Model	DJF for F400 / 410	Volt/Hz	Date of Modification	Serial Number
Modified Article	Parts Catalog			
Reason for Modification	Parts catalog correction

Model	DJF for F400/410	Volt/Hz	Date of Modification	Serial Number
Modified Article	Feed Roller Guide and Holder - Feed Roller Guide			
Reason for Modification	To prevent the original multiple feeding

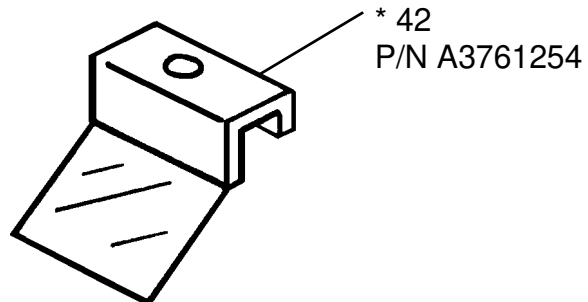
Incorrect P/N	Correct P/N	Description	Q'ty Used	Parts Catalog	
				Index No.	Page
12041123	12042367	Microswitch	1	111	11
		Microswitch - 250 VAC/0.1A

Model	DJF for F400/F410	Volt/Hz	Date of Modification	Serial Number
Modified Article	Belt Pressure Roller			
Reason for Modification	To improve the original transportation

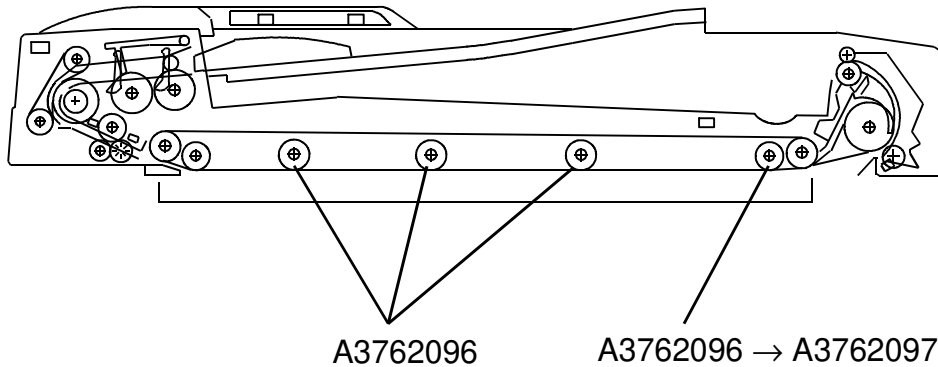
To improve the small size original transportation, one of four belt pressure roller is modified.
(The diameter is increased from 20mm to 24mm to apply more pressure.)

Old P/N	New P/N	Description	Q'ty Used	Inter-change-ability	Parts Catalog	
					Index No.	Page
A37362096	A3762096	Belt Pressure Roller	4 → 3	—	11	13
	A3762097	Belt Pressure Roller - Large	0 → 1	X/O	* 22	13

Model	DJF for F400 / 410 / 420 and DFC - α	Volt/Hz	Date of Modification	Serial Number
Modified Article	Original Exit Guide Mylar			
Reason for Modification	To ensure original stack in auto counting mode

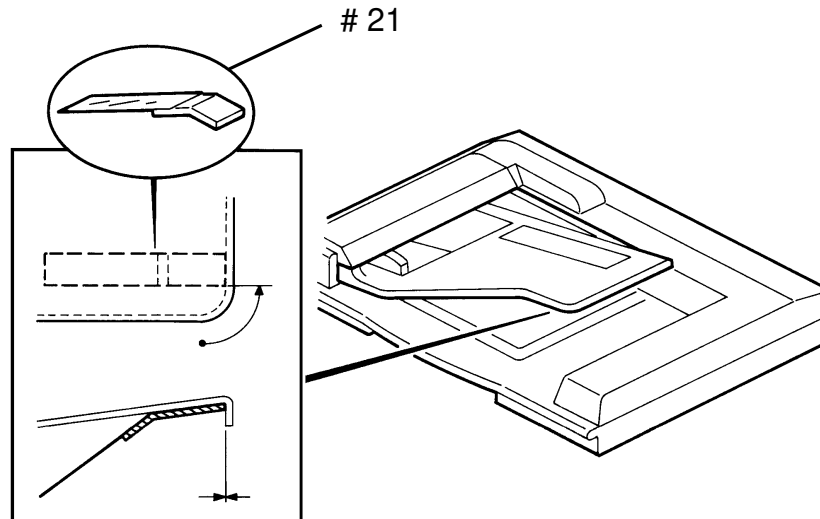
To ensure original stack in auto counting mode, the original exit guide mylar has been added as shown. For details please refer to F400 RTB - 033.

P/N	Description	Q'ty Used	Parts Catalog	
			Index No.	Page
A3764577	Original Exit Guide Mylar	0 → 1	* 21	5

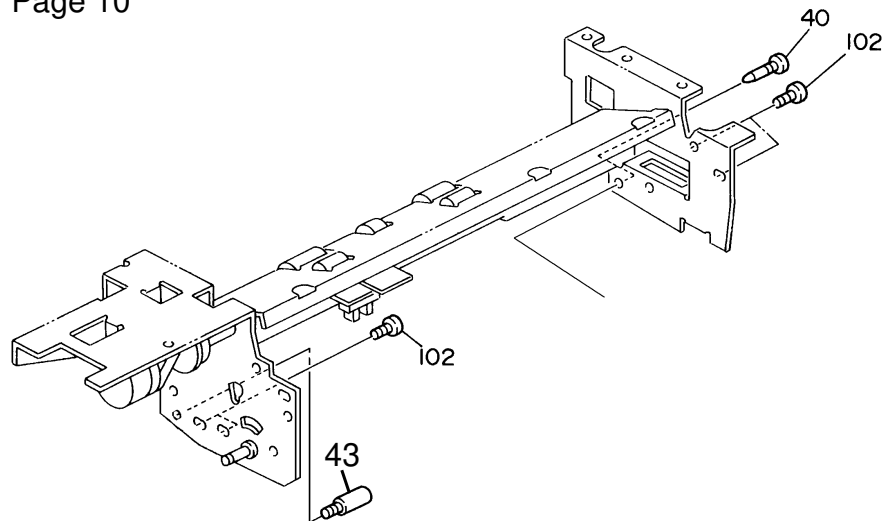
Please correct your parts catalog as follows:
Please add following parts.

New P/N	Description	Q'ty Used	Parts Catalog	
			Index No.	Page
54221737	Shaft	1	* 43	9

Model	DJF for F400 / 410 / 420 / DFC-α	Volt/Hz	Date of Modification	Serial Number
Modified Article	Guide Stud			
Reason for Modification	To prevent the upper registration guide from turning over the stopper.

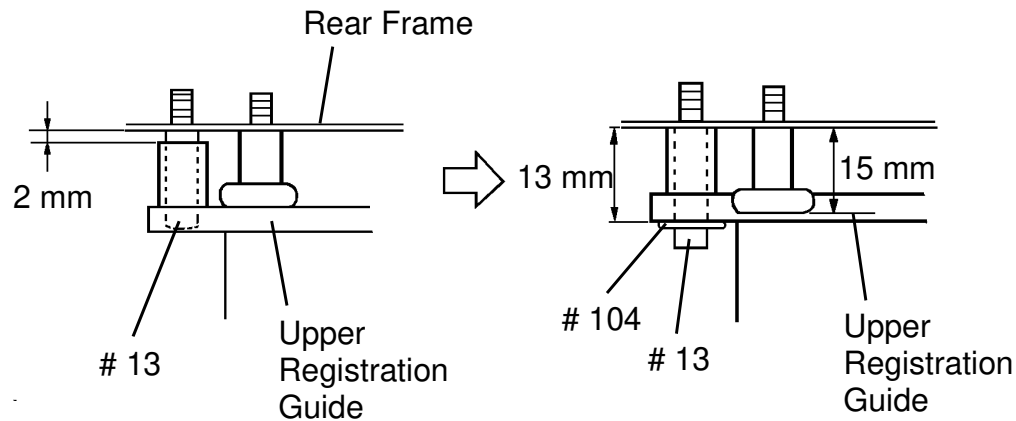
The upper registration guide contracts under a low temperature condition, and the side play of the guide becomes wider. This allows the guide to turn over the stopper in some cases. To prevent this by limiting the side play of the guide, the shaft has been changed in shape and a retaining ring has been added.

Old P/N	New P/N	Description	Q'ty Used	Inter-change-ability	Parts Catalog	
					Index No.	Page
A4693350	C2175524	Guide Stud	1 → 0	X/O	13	9
		Stud - Front Release Lever	0 → 1			
	07200040B	Retaining Ring - M4	n → n+1		103	9

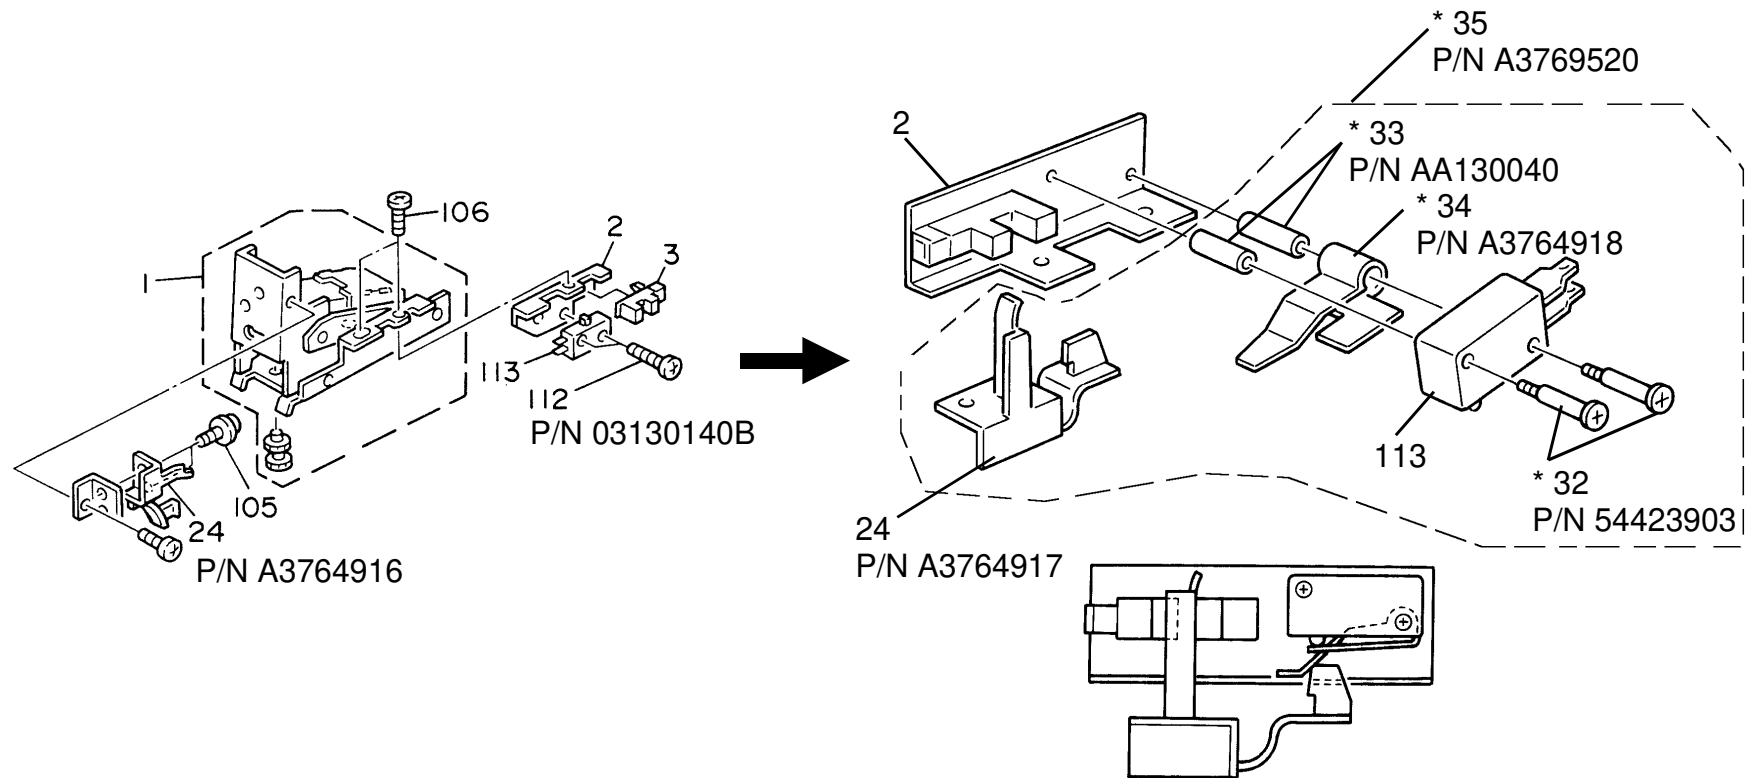
To prevent the reset switch lever (Index No. 24) from being broken, a spring plate (P/N A3764918) which works as a cushion has been added as shown.

When the old lever (P/N A3764916) is broken, please install the new parts as a set, because the old one will not be supplied as a service part. The set part number is A3769520.

Model	DJF for F400 / 410 / 420, DFC - α	Volt/Hz	Date of Modification	Serial Number
Modified Article	Hinges			
Reason for Modification	To increase durability

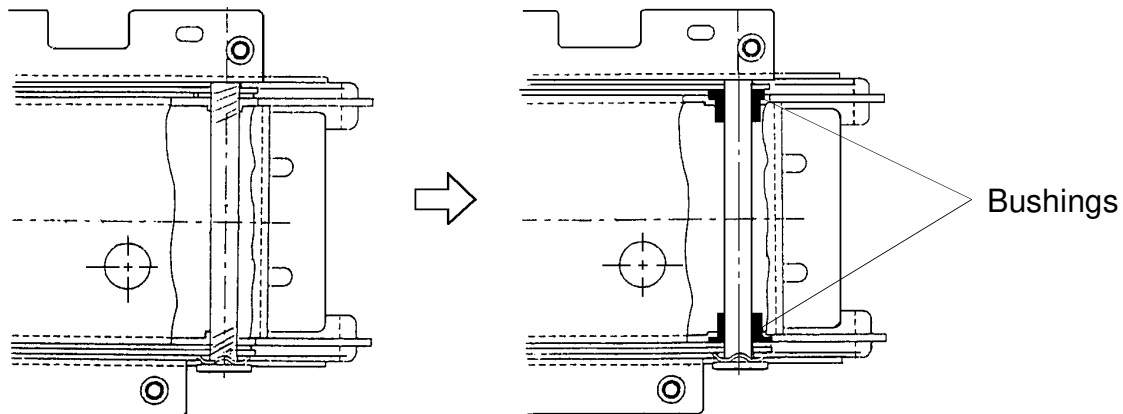
To increase the durability of the left and right hinges, two bushings have been added as shown below.

Old P/N	New P/N	Description	Q'ty Used	Inter-change-ability	Parts Catalog	
					Index No.	Page
A3764160	A3764159	Left Hinge	1 → 1	X/O	1	17
A3764190	A3764189	Right Hinge	1 → 1	X/O	5	17

Model	DJF for F400 / 410 / 420	Volt/Hz	Date of Modification	Serial Number
Modified Article	Feed Roller Guide			
Reason for Modification	To prevent the transport belt going behind the frame.

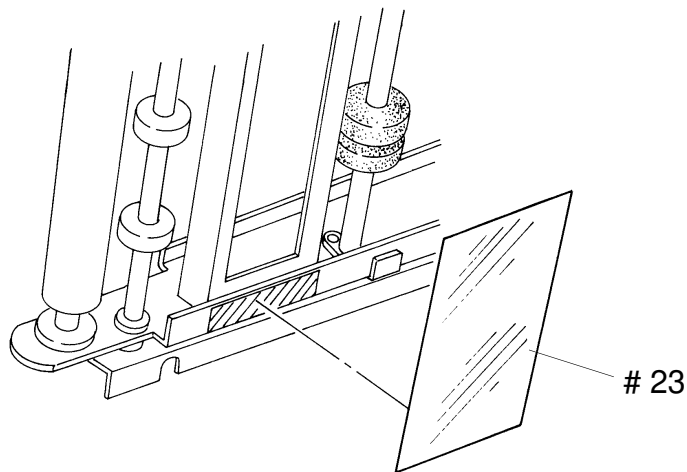
To prevent the transport belt going behind the rear transport frame and being pressed by book originals when the DJF is closed, the guide mylar has been added.

New P/N	Description	Q'ty Used	Inter-change-ability	Parts Catalog	
				Index No.	Page
A3761252	Feed Roller Guide	0 → 1	—	* 23	13

MODIFICATION BULLETIN NO. 16

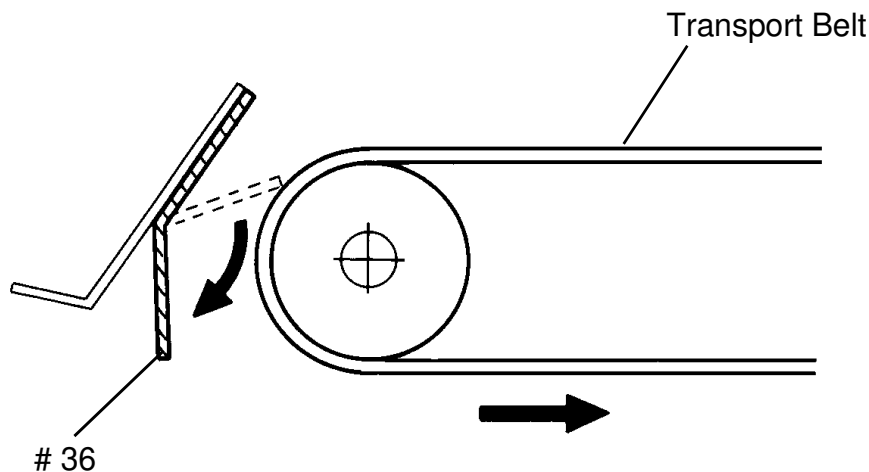
New material (urethane) has been employed for the separation guide mylar. The new mylar always resets to the correct position as the transport belt turns due to its softness, even if the mylar is bent up when installing the transport belt.

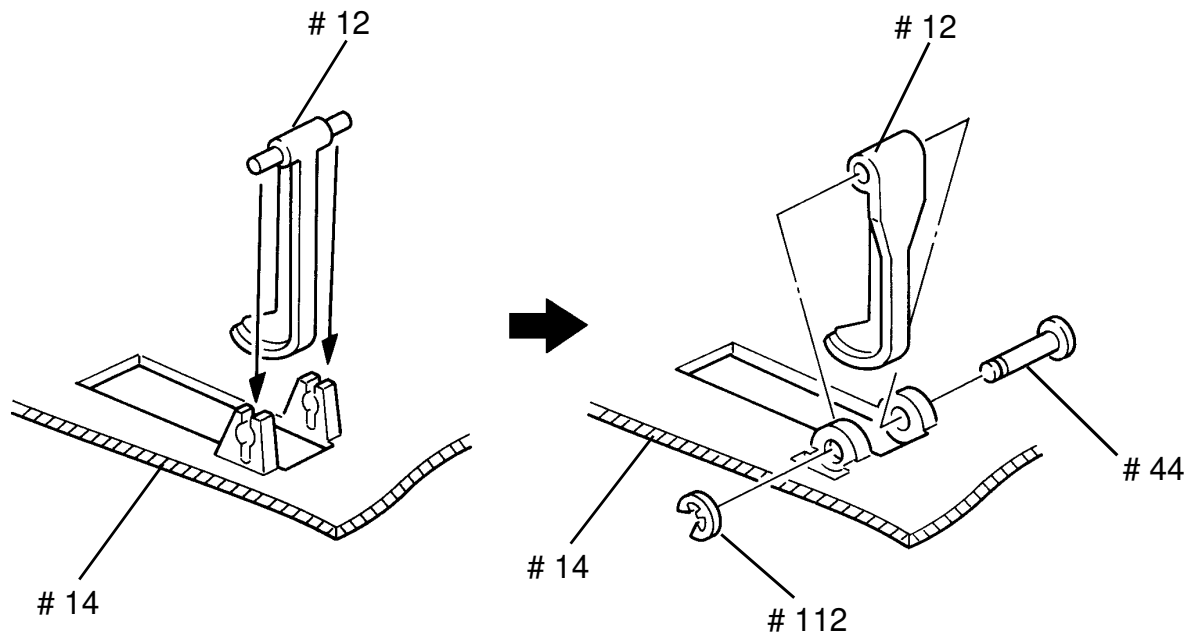
To prevent the feelers for the original set and feed sensors from popping off during the operation by a customer, the mounting design has been changed from a snap-in type to a pin-fix type as shown below.

The old type sensor feeler is no longer available because the mold had been changed for the new type. Therefore, please install all the new type parts as a set when the old type feeler needs to be replaced. This action is also recommended to prevent the above problem.

Model	DJF for F400 / 410 / 420	Volt/Hz	Date of Modification	Serial Number
Modified Article	Inverter Pawl			
Reason for Modification	Part standardization with other models

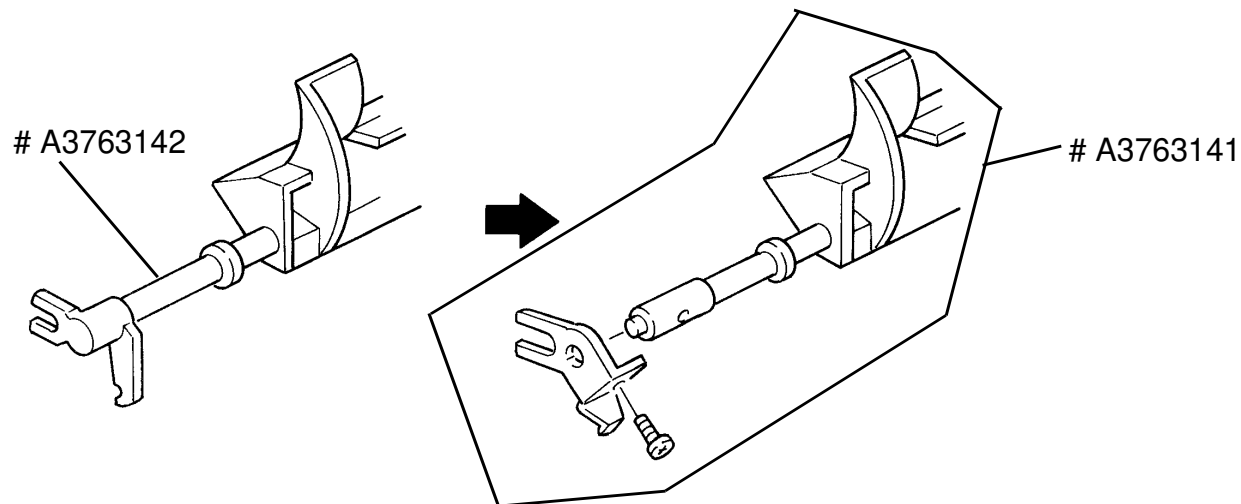
The following part has been changed for part standardization purposes.

Old P/N	New P/N	Description	Q'ty Used	Inter-change-ability	Parts Catalog	
					Index No.	Page
A3763142	A3763141	Inverter Pawl	1 → 1	O/O	6	15

Model	DJF for F400 / 410 / 420	Volt/Hz	Date of Modification	Serial Number
Modified Article	Switch Lever Bracket			
Reason for Modification	Per Field Request

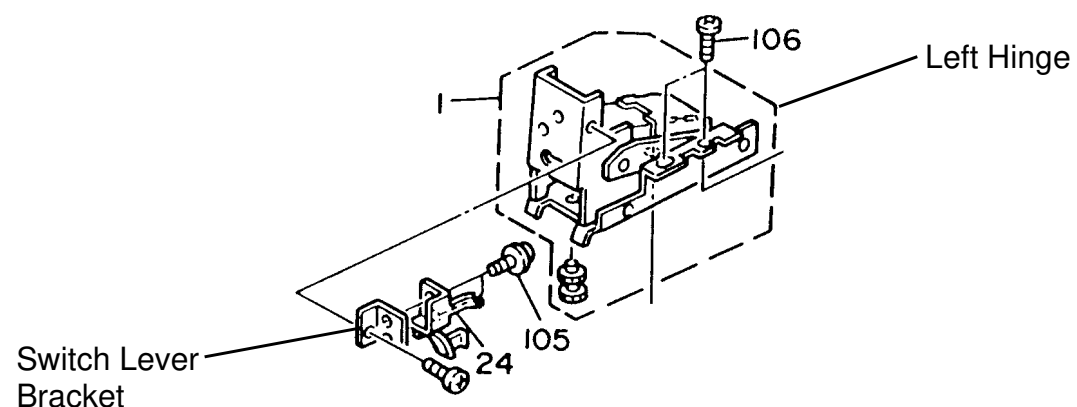
The switch lever bracket, which is originally included in the left hinge, has become available as an independent service part.

New P/N	Description	Q'ty Used	Parts Catalog	
			Index No.	Page
A3764151	Switch Lever Bracket	0 → 1	* 36	17

Model	DJF for F400 / 410 / 420	Volt/Hz	Date of Modification	Serial Number
Modified Article	LED - Green			
Reason for Modification	Parts catalog correction

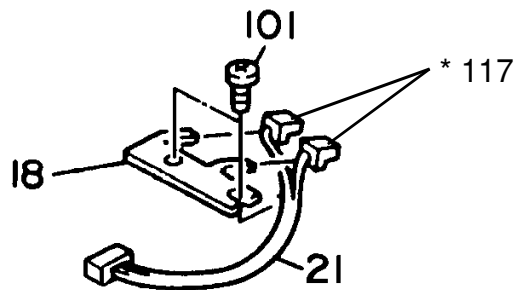
Please add the following to your parts catalog.

New P/N	Description	Q'ty Used	Parts Catalog	
			Index No.	Page
14030493	LED - Green	0 → n	* 117	17

Model	DJF for F400 / 410 / 420 / DJF-α	Volt/Hz	Date of Modification	Serial Number
Modified Article	Bracket - Idle Roller Arm			
Reason for Modification	To maintain the pressure of the pull-out roller

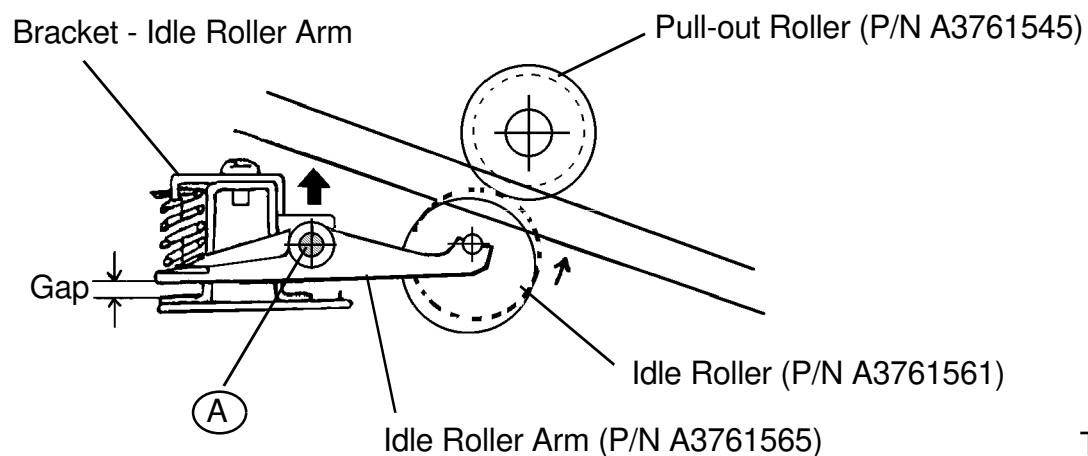
Over time, wear on the pull-out roller leads to a decrease in pressure (as well as a reduction in the gap) and may result in original jams or incorrect size detection.

To prevent this, the position of the stud (A) in the bracket-idle roller arm has been raised by 1 mm to maintain the pressure.

Incorrect P/N	Correct P/N	Description	Q'ty Used	Inter-change-ability	Parts Catalog	
					Index No.	Page
A376 1223	A376 1224	Bracket-Idle Roller Arm	2 → 2	X/O	3	7
